Final Environmental Impact Statement for Remedial Action Standards for Inactive Uranium Processing Sites (40 CFR 192)

Volume II

APPENDIX D: RESPONSE TO COMMENTS

FIGURE 1 RADON - 222 FLUX AT SURFACE FROM A 15-cm THICKNESS OF TAILINGS VERSUS DEPTH BELOW SURFACE

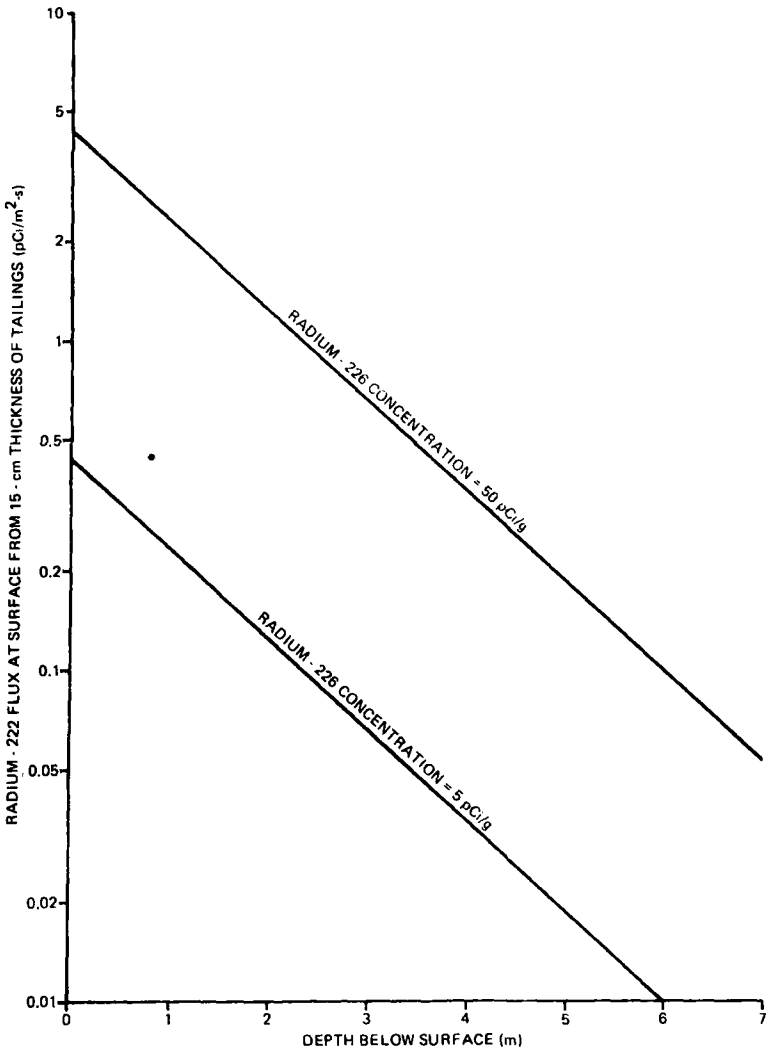
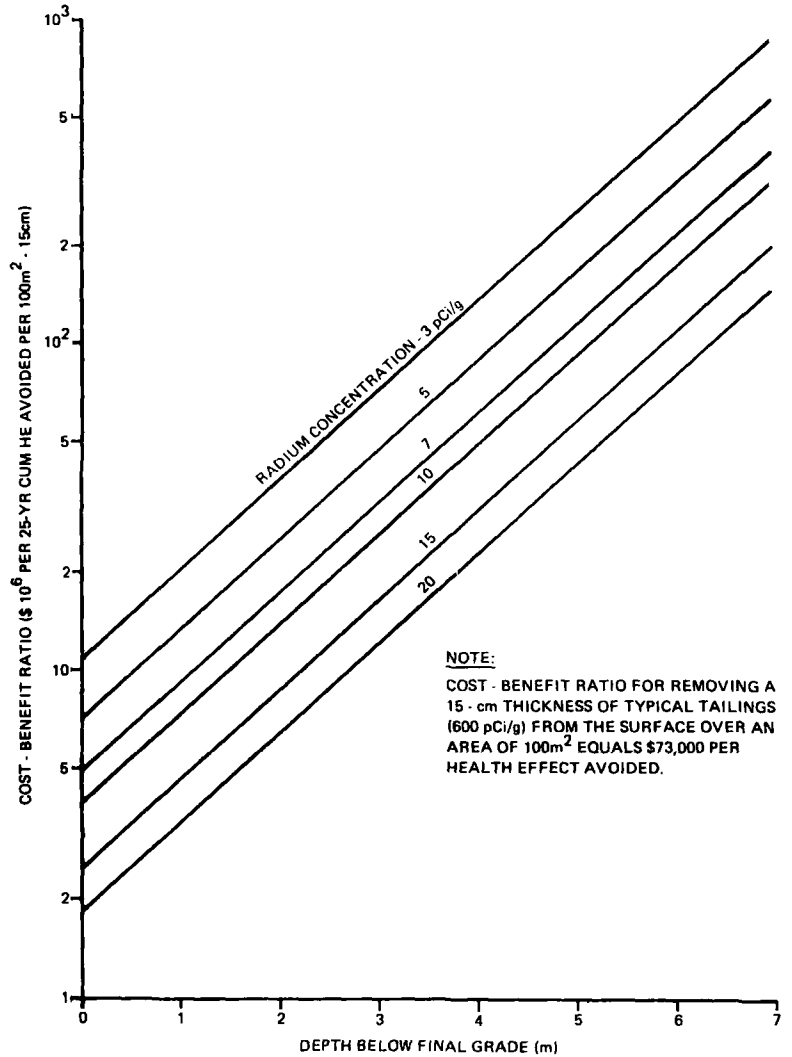
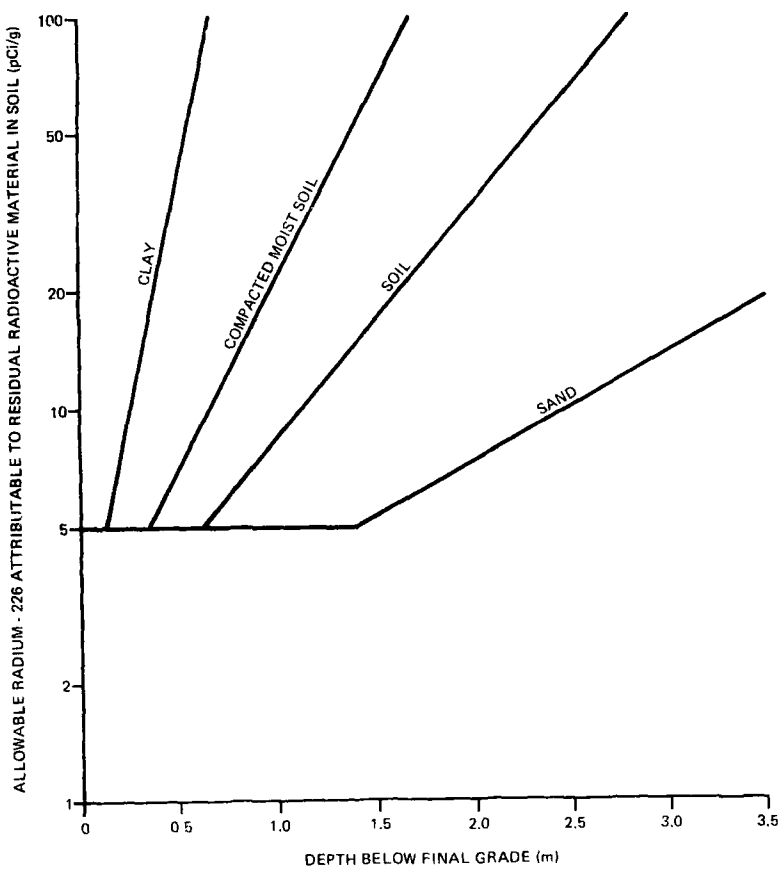
From Figure 1 it can be seen that a 15-cm thickness of tailings or contaminated material which is covered by slightly more than 1 m of dry soil and whose radium-226 concentration is about 50 pCi/g will produce a flux at the surface of about 2 pCi/m^2-s. Suppose then that contamination extends to 1 m below the intended final grade and the average radium-226 concentration attributable to residual radioactive material at 1 m below the final grade is 5 pCi/g, as required by the proposed cleanup standards. The radon-222 flux at the final grade which would result from a 15-cm thickness of such contaminated soil at the 1-m depth would be about 0.2 pCi/m^2-s. Thus the proposed cleanup standard under likely conditions may be much more restrictive than the proposed disposal standard, in terms of release of radon-222 to the atmosphere. That is to say, whereas the proposed disposal standard allows radon-222 release to the atmosphere which is considered acceptably low in terms of risk to the public, the proposed cleanup standard for contaminated open lands under likely conditions would potentially require a radon-222 release rate 10 times smaller. Finally, the question is raised, "If the risk to the public is acceptably low for disposal of tailings and contaminated material, why should the contaminated material be cleaned up to standards which may be 10 times more restrictive?"

benefits of removing 15 cm of contaminated soil (or tailings) under various conditions, as well as the resulting benefits, were estimated for a 100-m^2 area at the Vitro site in Salt Lake City. The cost-benefit ratio is presented in Figure 2 as a function of depth below final grade, with radium concentration as a parameter.

The note on Figure 2 shows that removal of 15 cm of typical tailings (600 pCi/g of radium-226) from 100 m^2 of the present surface has a cost-benefit ratio of about $73,000 per health effect (case of lung cancer) avoided. This suggests that removal of the top 15 cm of tailings is a very cost-effective undertaking, when measured in terms of health effects avoided. By contrast however, the cost-benefit ratio of removing 15 cm of contaminated soil with a radium-226 concentration of 10 pCi/g at a depth of 1 m below final grade is a startling $9,000,000 per health effect avoided, or more than 100 times less cost-effective.

Continuing the illustration, imagine that excavation during cleanup had extended to a depth which was 1 m below the intended final grade, and the radium-226 concentration was found to be 10 pCi/g in the next 15 cm of soil. Also allow that the naturally-occurring radium-226 in soil of the general vicinity is known to range from 2 to 3 pCi/g. The answer to the question of whether to remove an additional 15 cm of contaminated soil at that depth is suggested by reference to Figure 2. Since the return is so small compared to the additional investment required ($9,000,000 per health effect avoided), the judgement is made that decontamination is complete, even though the radium-226 attributable to residual radioactive material is in excess of the presently proposed standard by as much as 3 pCi/g. Even under these conditions, the radon-222 released to the atmosphere will not exceed 0.5 pCi/m^2-s -- which is well below that allowed if the contaminated material were disposed of at that location.

Because of the potential contradiction between the proposed standard for cleanup of contaminated open lands and the proposed standard for tailings disposal, and because of the need for common sense, allowing for the exercise of good judgement during decontamination, the standards for cleanup of contaminated open lands should be relaxed. The concept depicted in Figure 2 forms a rational basis for a quantitative tool to be used in such exercise of good judgement.

Figure 1

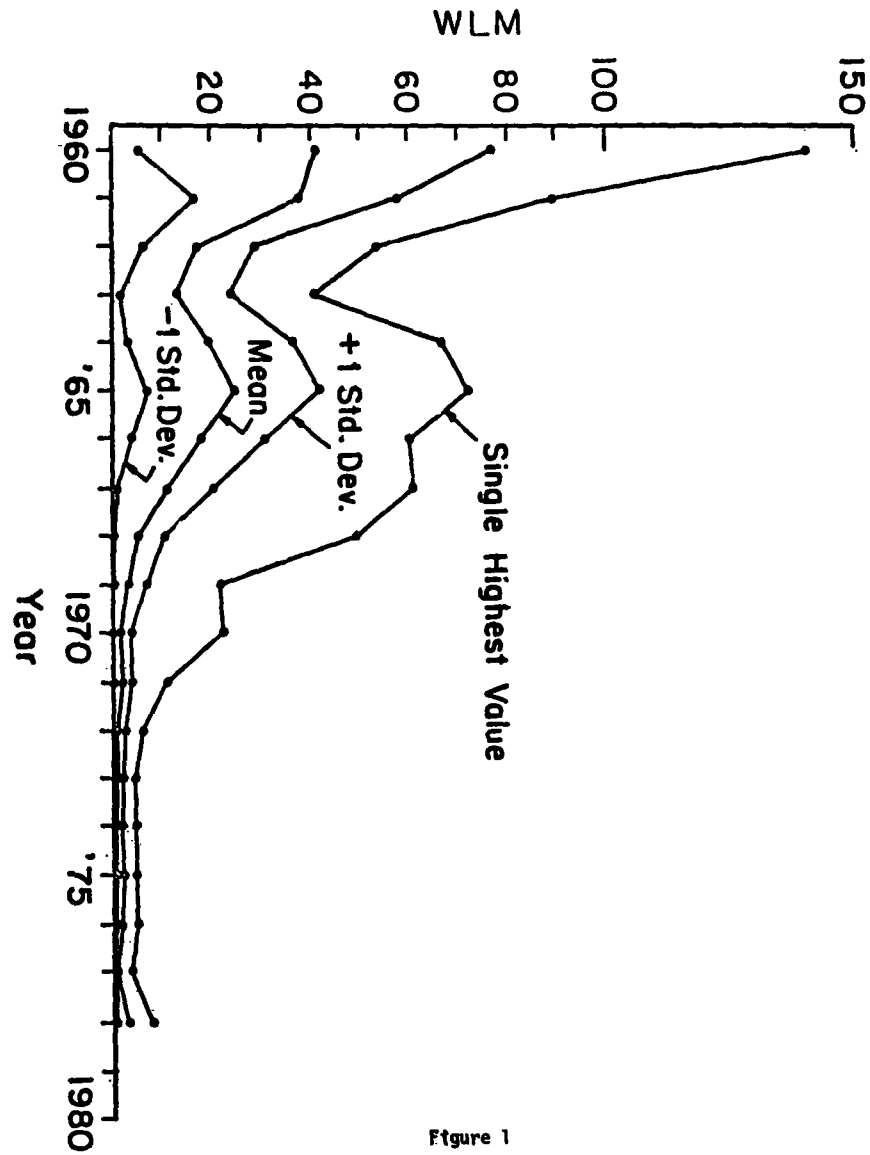
subject. He reports that uranium miner has a working average life time of 60 WLM. That is intermediate between the previous lowest levels of exposure for which lung cancers were identified (they were in the range of 120 to 240 WLM) and the average environmental exposures which are about 16 WLM. Dr. Cohen uses both the term loss of life expectancy (LLE) and the standardized mortality ratio (SMR) but we will concentrate on just LLE for simplicity.

FIGURE 1

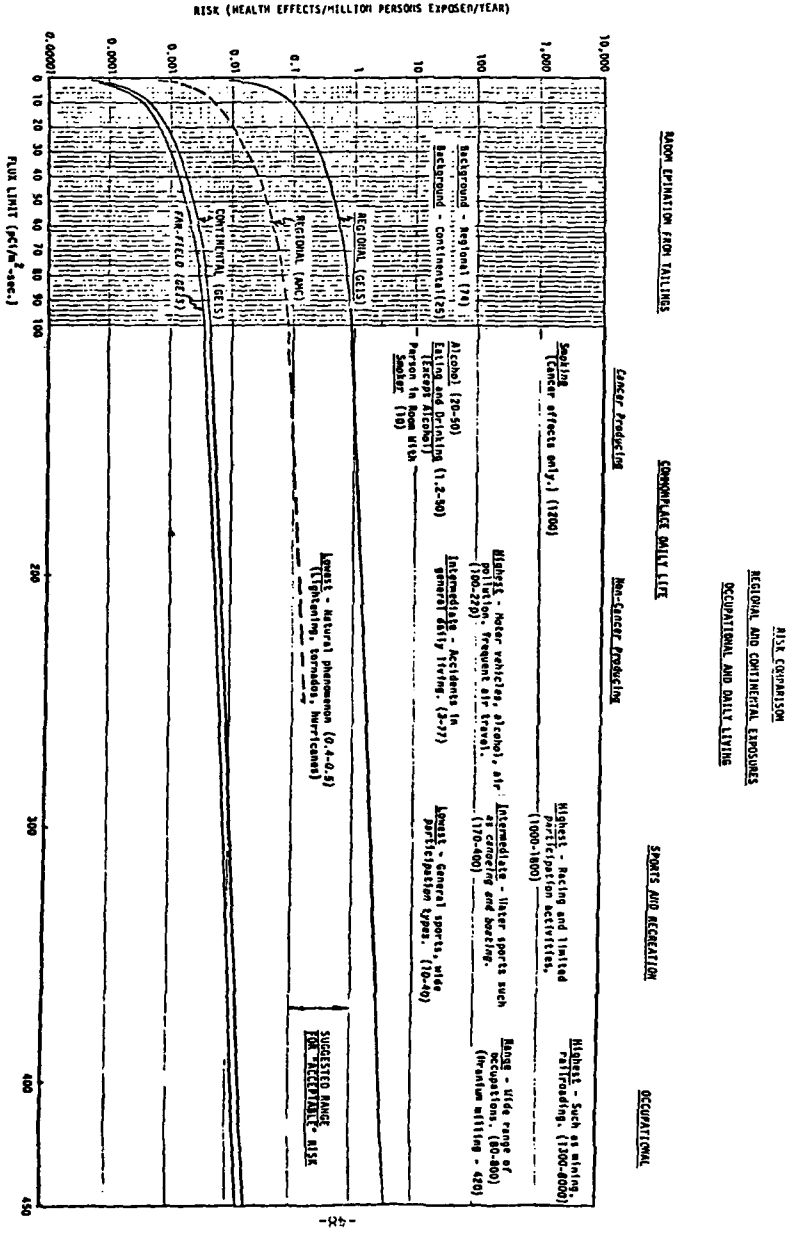
the curve for regional GEIS, continental GEIS, the far field GEIS, plus the American Mining Congress' own interpretation of the data—the value that you're talking about (2pCi/m^2-sec) is almost down here at this edge near zero risk. And if we accept what I understand are the normally accepted risks to the general population, and any health physicist can correct me, they should be between 0.1 and 1 health effects. Any one of these curves at 2 is well below the 0.1 to 1 health effects range. We could even go up to 10 pCi/m^2-sec on the most conservative one before reaching 0.1 health effects.
